Technical Service Bulletin: TSB120224

Released Date: 08-Mar-2022

New Turbocharger Kit Containing B16 bolt for 0.25 mm [0.010 in] Shim

Figure 1 - Turbocharger Kit, Part Number 4034095 Contents

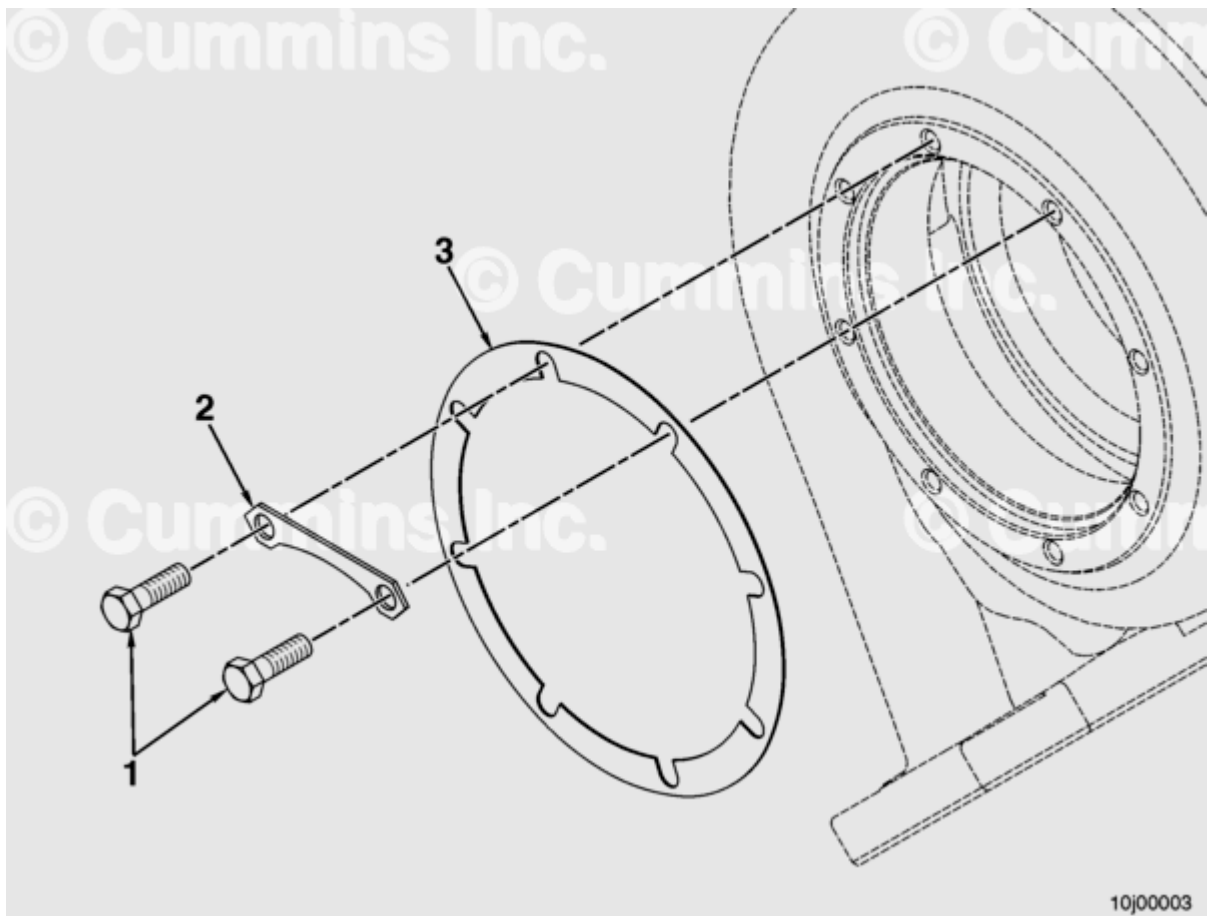
This document announces the release of a new turbocharger kit, Part Number 5357484. This kit is intended as a Step 3 solution for an active serious quality problem project investigating the A286 stainless steel capscrews breaking in the bearing-to-turbine housing joint. The turbocharger kit will contain new B16 capscrews (1), and new lock plates (2). The 0.25 mm [0.010 in] shim is fitted between the flange of the bearing housing and the turbine housing. See Figure 2 (ordered separately).

Figure 2 - Shim Location

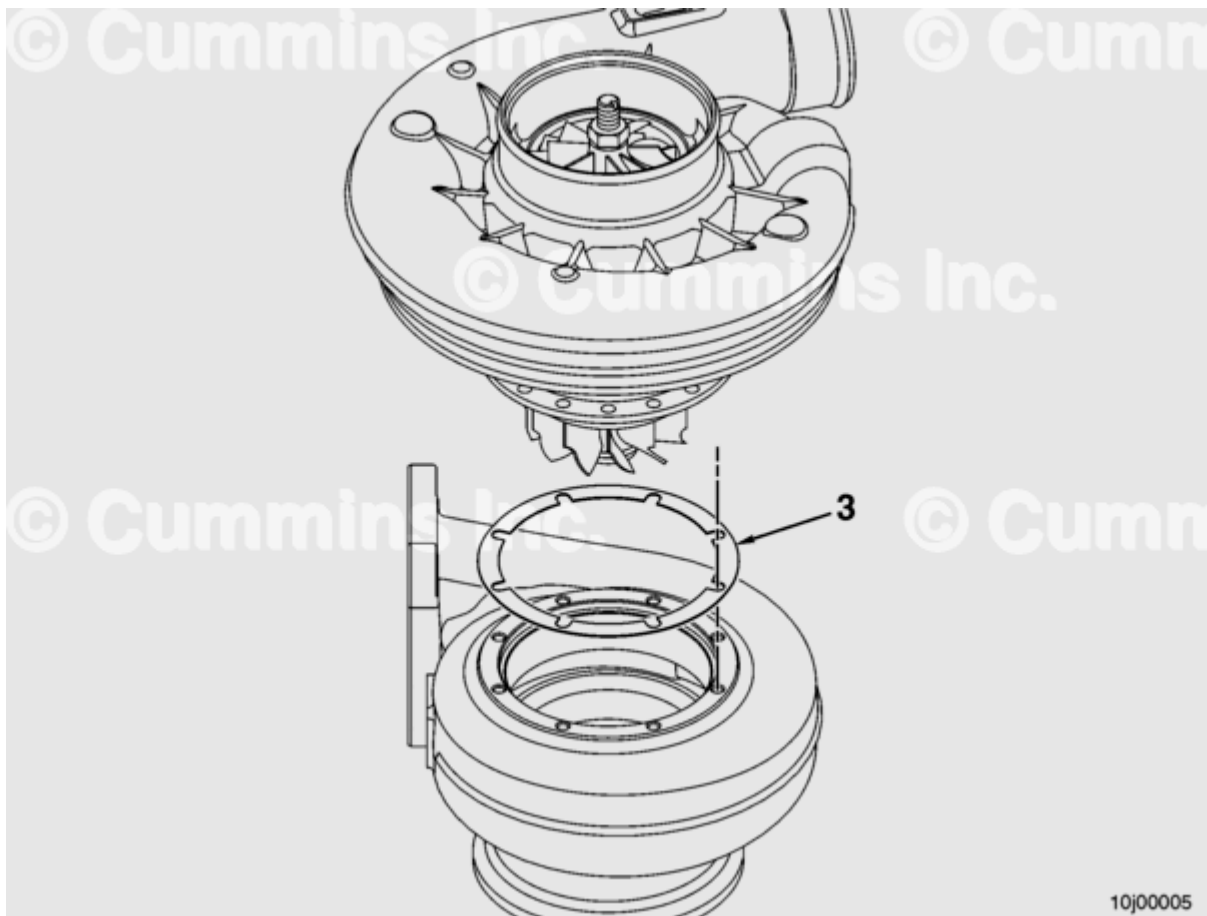
Shims can only be installed on turbochargers that do not use the C-seal.
